# CERTIFICATE OF APPROPRIATENESS PLACARD

Remove shingle roofing; install standing seam metal roof; construct rear deck; remove existing rear window; install rear French doors; alter exterior paint colors; replace non-original front door; remove front storm windows; replace wall-mounted mailbox; install electric car-charging station; install gas water heater; reinstall original columns and railing

1103 W Cabarrus St

COA-0054-2022

# Scaled Site Plan 1103 W Cabarrus St

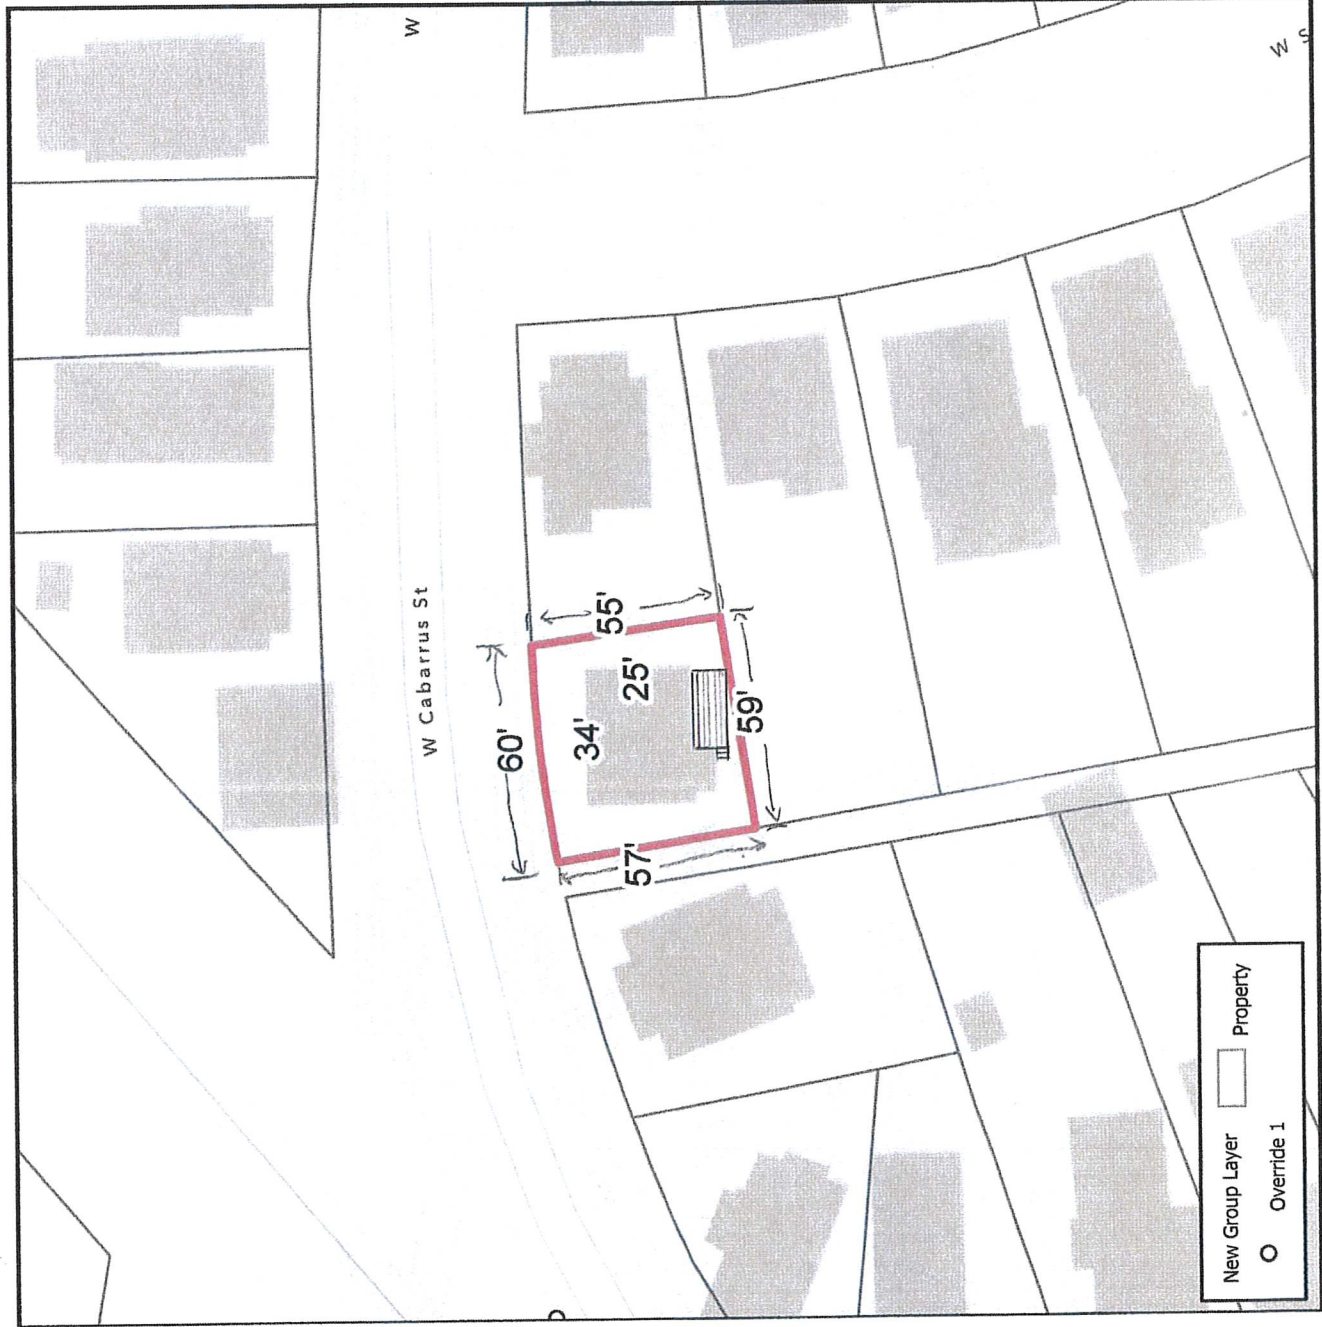
- Please mark the site plan with overall deck dimensions (all 4 sides) and the proposed deck's distance from the property line. **To be provided next week. Ulrich to provide via email.**

- Provide a scaled proposed site plan with: property lines, building footprint, proposed deck/steps. This will be important for us to determine if the proposed deck can remain a minor work item. **See attached.**

# First floor

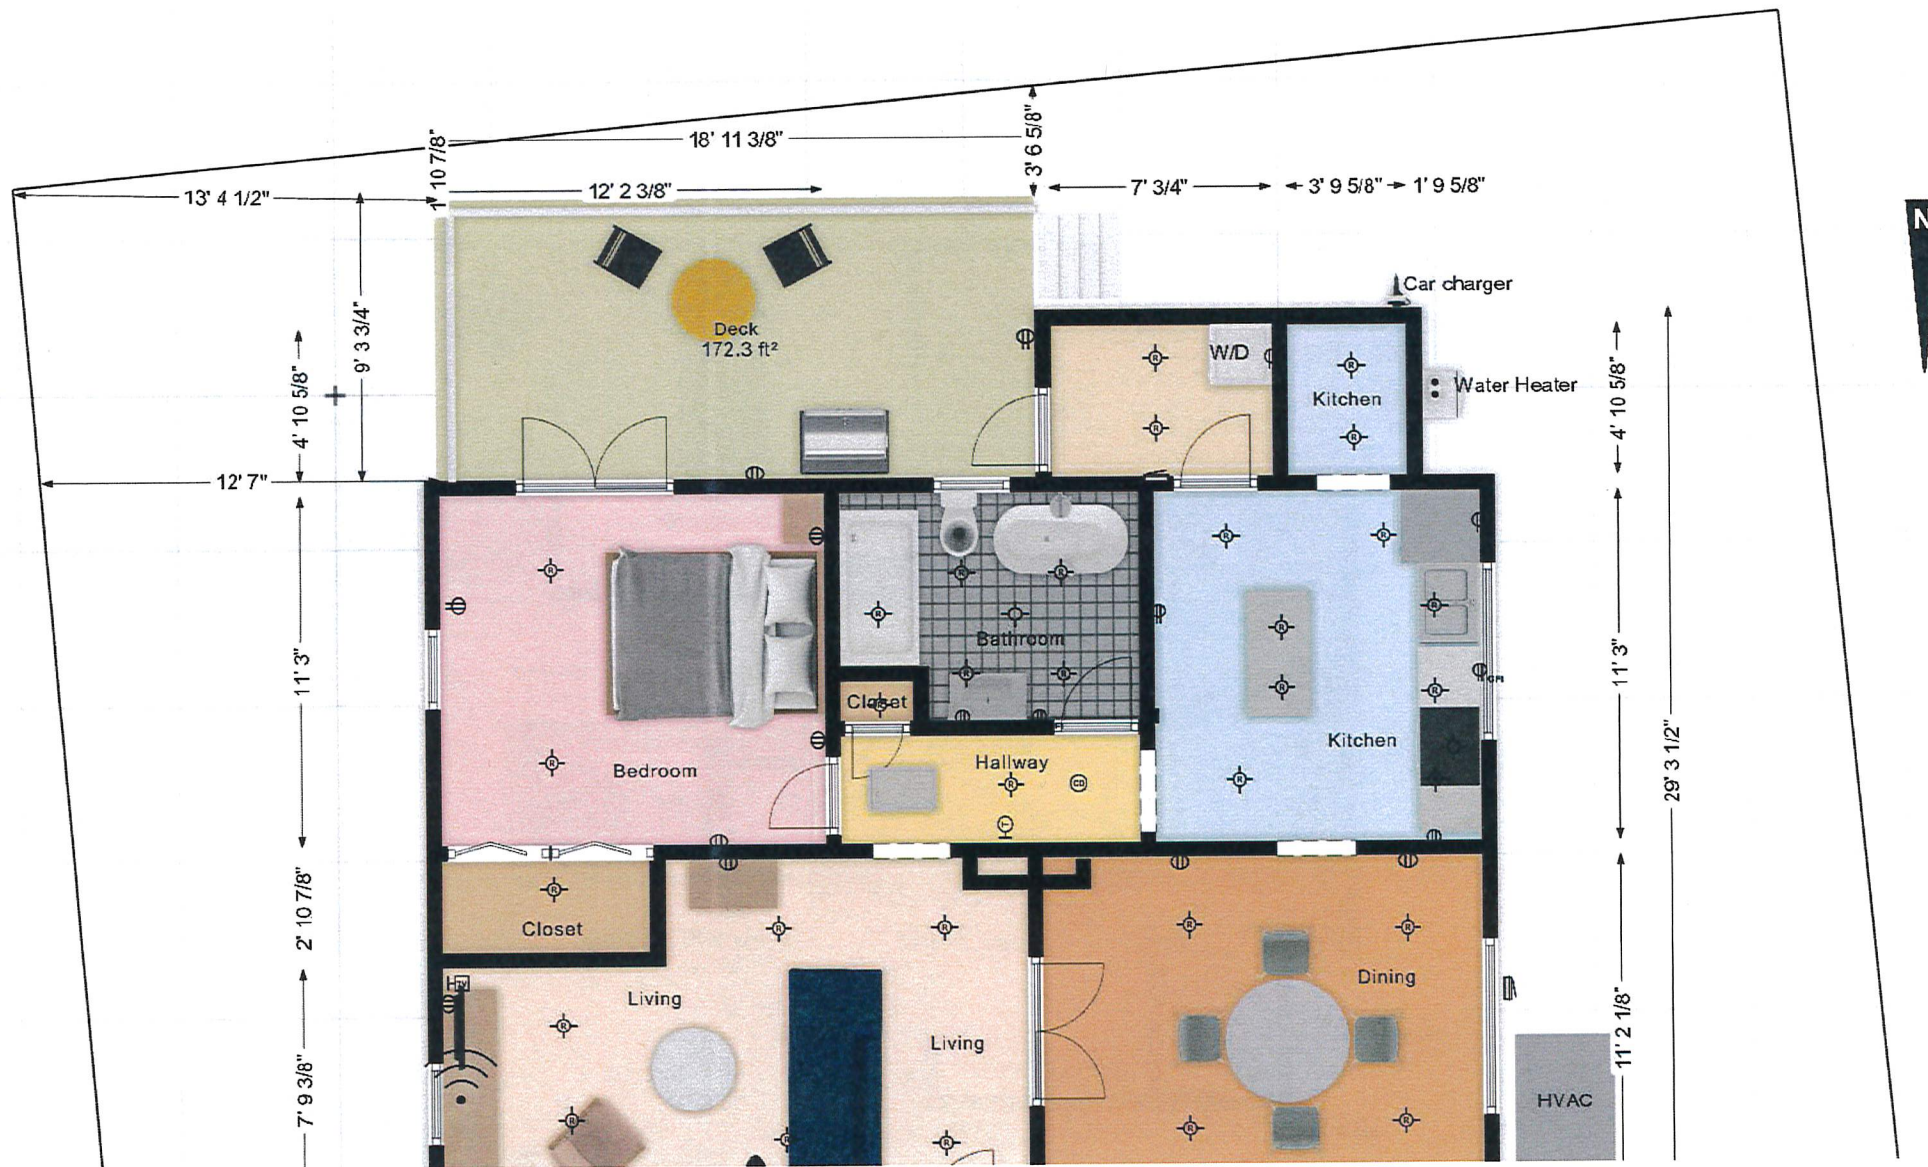
- The deck should be inset from edge of house by at least 4". Please provide a revised floor plan. **Revised floor plan attached. Deck inset by 6" on East side, mail box, car charger and water heater labeled.**

- Provide detail photos of the front storm windows to be removed. **See attached.**
- Provide noting on the ground floor plan to identify proposed locations of the water heater, car charger, and mailbox. **See attached/ bullet point 1.**

RAILING 1031 W SOUTH STREET + CABARRUS ST <sup>1103 W</sup>

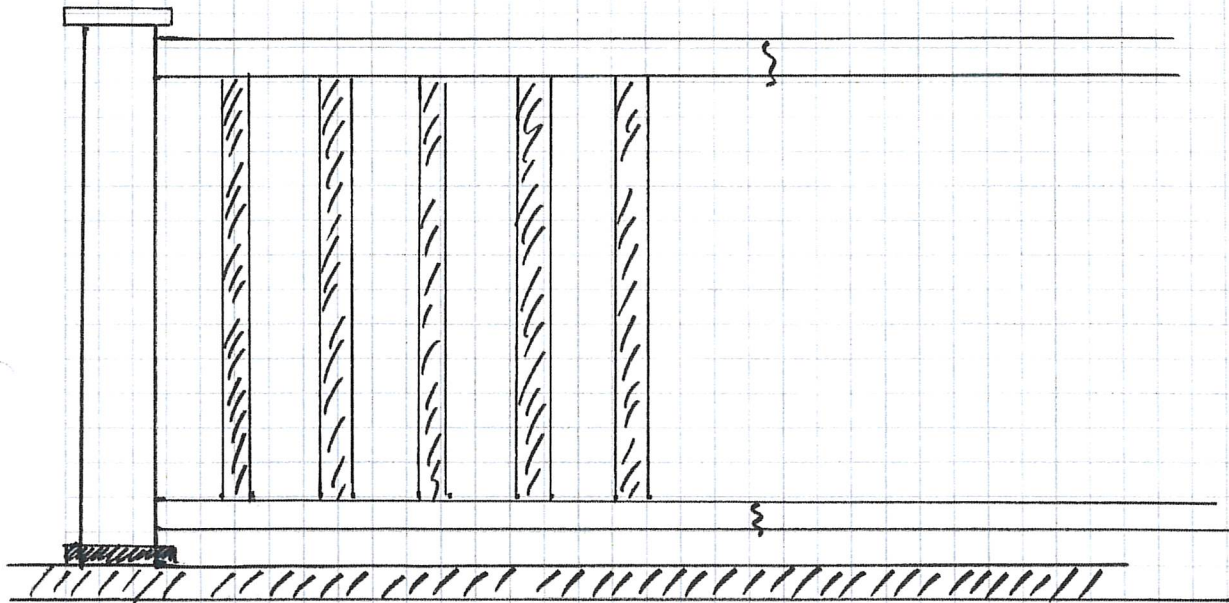
- Provide a scaled railing section detail for the proposed deck. What are the proposed materials of all deck railing elements (i.e. balustrade, railing itself, post caps)? What are the proposed finish colors for each of these elements? Material is supposed to be Timber Tech. **I'll have material samples with me next week. TimberTech is approved for use as decking boards. Thank you for agreeing to amend the railing to be all wood. Please provide a railing section detail and final finish color in writing.**

1103 CABARRUS ST  
SOUTH ELEVATION  
BEFORE

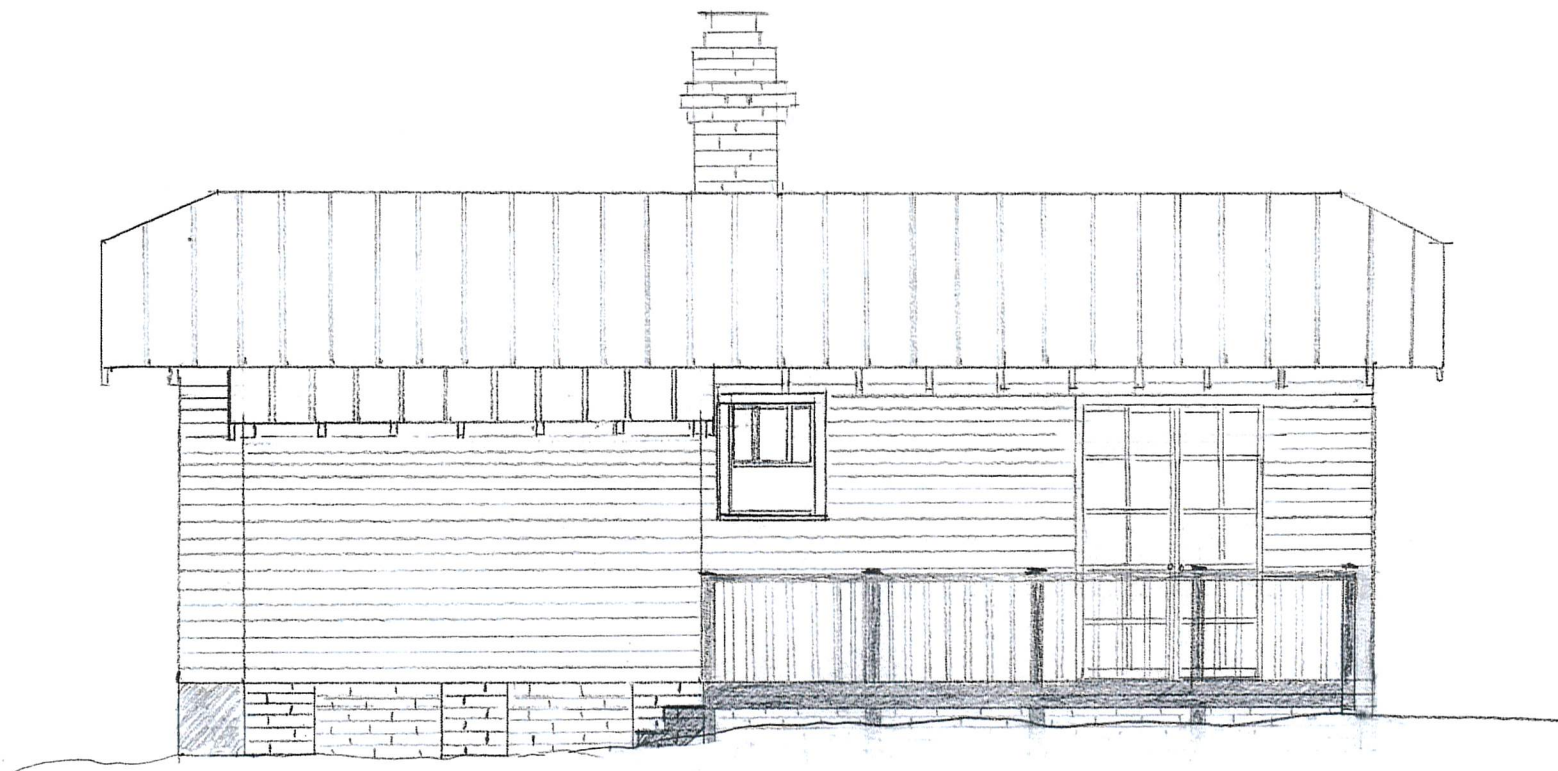
- Provide existing & proposed scaled elevation drawings for rear window removal/French door installation and deck construction. **See attached.**
- Provide French door manufacturer's specifications, including scaled section detail, trim, material, and color. **Marvin Elevate. Outswing French door. Specs attached.**
